UNITED STATES PATENT AND TRADEMARK OFFICE

10/698,134

Raymond M. Genick II

DETAILED ACTION

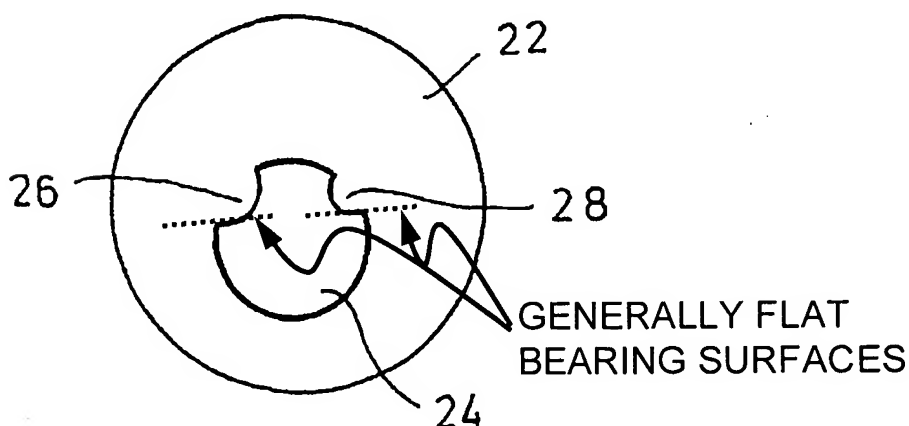
- a threaded fastener 1 defining a pair of longitudinal channels 18, 20, each channel defining a generally flat bearing surface and a concave curved portion (Figures 1-3, 6) (Figure A below) (col 4, lin 3-5)

4. Applicant argues none of the references disclose a fastener having channels defining a generally flat portion and a concave curved portion. Examiner disagrees and draws reference to Figure A of this Action, which is annotated Fig 3 of Hofschneider showing generally flat bearing surfaces and concave curved surfaces associated with the channels. Examiner also draws attention to Hofschneider Fig 6, which more clearly shows a flat portion and a concave portion of the slot, and notes Hofschneider discloses that individual features of the various exemplary embodiments may be used in any combination (col 4, lin 3-5).
